SB-GA8-2005-22

# **Service Bulletin**

| Rudder Trim Tab Installation   |
| All GA8 serial numbers GA8-00-004 through GA8-05-070.  |

Figure 1: Finished rudder trim tab installation (looking from R.H.S of the Rudder).

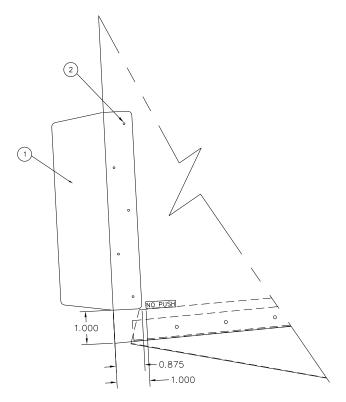
| Rudder Trim Tab Installation   |
|--|
| To improve the rudder trim, a ground adjustable rudder trim tab has been developed. It is recommended the trim tab be incorporated after the rear wing spar adjusting bush is installed. Refer to SB-GA8-2004-12 for the installation procedure of adjusting bush. |
| Calculate balance of the rudder using the perpendicular distance from the hinge line to the trim tab. The distance is 28 inch for the location of trim tab shown in Figure 1.  |

- 1. Remove NO PUSH Placard from the R.H.S of the rudder
- 2. Position the Trim Tab as per hinge line and drill off rivet holes using drill size 2.5mm.
- 3. Coat faying surface of tab with neutral cure white silicon and install tab using item 2.
- 4. Install new 'NO PUSH' placard as shown in Figure 1.
- 5. The bend angle can be adjusted to accurately trim each individual aircraft. Increase the bend to correct a left turn and decrease to correct a right turn.

6. Confirm that the mass and balance of the rudder are within manufacturers limits. (See service manual section 51-60-20).
